**IMPORTANT – RECALL NOTICE - #####**

**This Notice Applies to Your Trailer [Insert VIN]**

Kaufman Trailers of NC, Inc. has determined that a defect, which relates to trailer safety, exists in certain 2018 - 2021 Kaufman Trailer 25,000 GVWR Deluxe Tandem Dual Gooseneck Dump Trailers – 20' x 90". These are Model numbers: **FX-10K-20D & FX-10K-20D-SC**. On most of these models, the angle ramp track at the rear of the trailer that holds the lip of the aluminum ramps (once installed) is not properly braced (see pictures below). The improper bracing *could* cause the welds to break on the angle ramp track causing immediate collapse of the ramps while loading/unloading equipment utilizing the aluminum ramps. This could cause injury or death to any person(s) that is behind or near the rear of the trailer or to the operator of the equipment being loaded/unloaded.

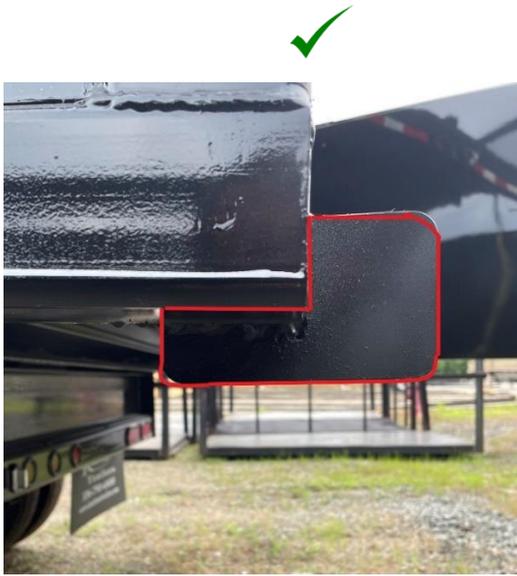
Verify you own the trailer with the specific VIN listed at the top of this page. If so, a visual inspection of the rear of the trailer, specifically the angle ramp track, against the below pictures will verify if you need to install the proper bracing. If the angle ramp track appears defective, as illustrated in the

photos below, you should immediately cease use of the aluminum ramps in your 25,000 GVWR Deluxe Tandem Dual Gooseneck Dump Trailer – 20' x 90" for the purpose of loading/unloading equipment.

Kaufman Trailers of NC, Inc. will provide two (2) end brace caps to be welded at the ends of the angle ramp track as well as one (1) center support gusset to be welded inside the angle ramp track at the center of the trailer rear. When the braces are installed correctly, this will prevent the angle ramp track welds from breaking. In some cases, additional welding may be needed for further reinforcement as show in the attached picture.
